Reference: Hanford Waste Vitrification Plant
 DOE Contract DE-AC06-86RL10838
 Fluor Contract 8457

DESIGN CHANGE NOTICE

DCN - 0049

Change Swing of
Security Gate

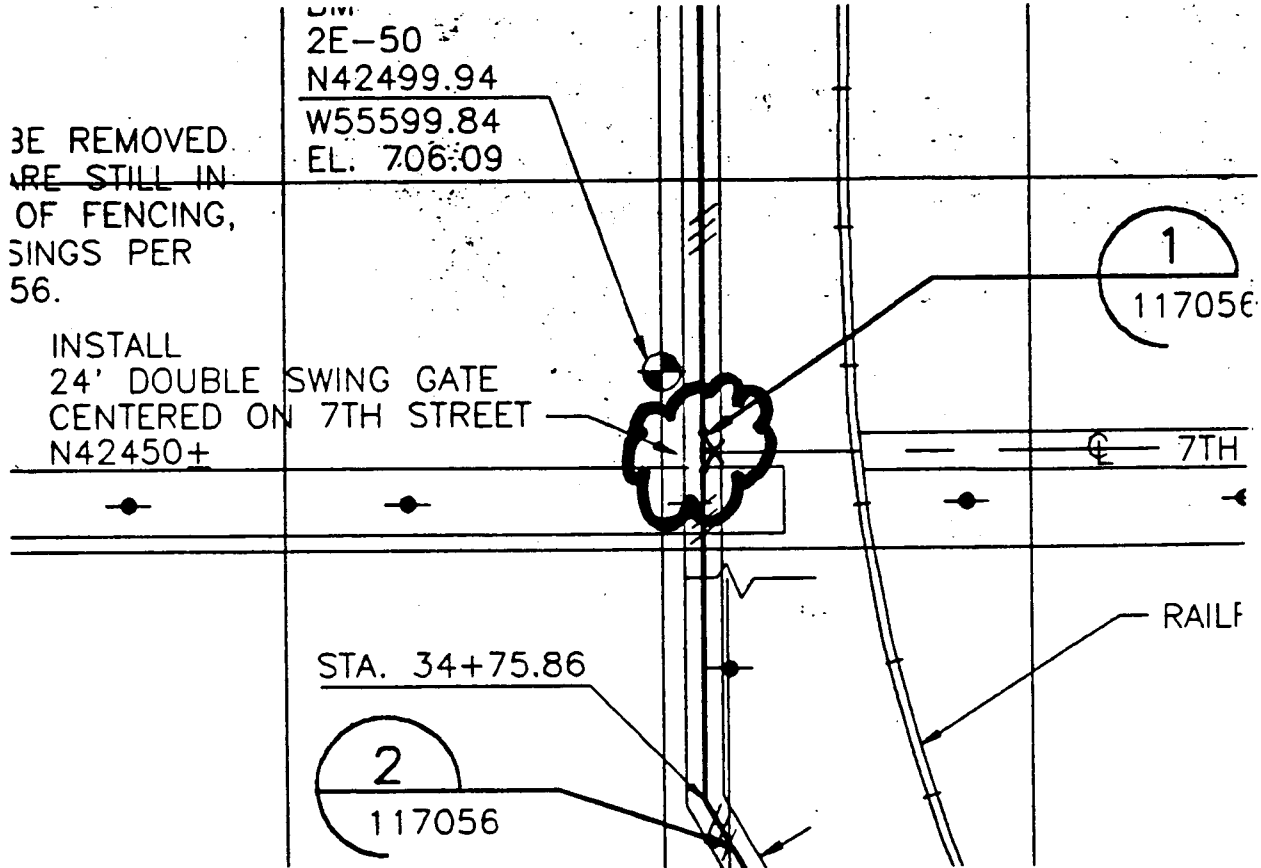
FLUOR DANIEL		U.S. DEPARTMENT OF ENERGY HANFORD WASTE VITRIFICATION PLANT		DESIGN CHANGE NOTICE	
DESCRIPTION OF CHANGE <i>Change depiction of gate swing.</i>				BASE DOC. NO. H-2-117023 SHT/PG. 1/1 REV. 1	
				DISCIPLINE: CIVIL	
PREPARED BY: <i>G. Coyer</i>		DATE: 6-2-93		REV PAGE	
DISCIPLINE ENGINEER: <i>Blum & Coyer</i>		DATE: 6-2-93		DCN - 0049 0 3

INSTALL
 24' DOUBLE SWING GATE
 CENTERED ON 7TH STREET
 N42450+

BASE DOC. NO. H-2-117054

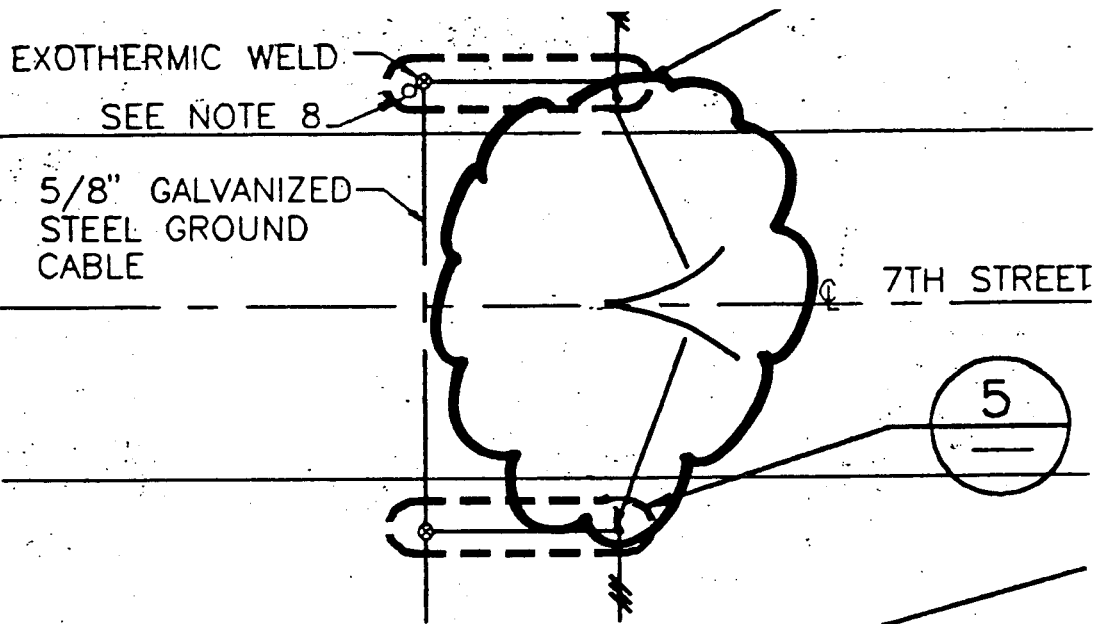
Change depiction of gate swing.
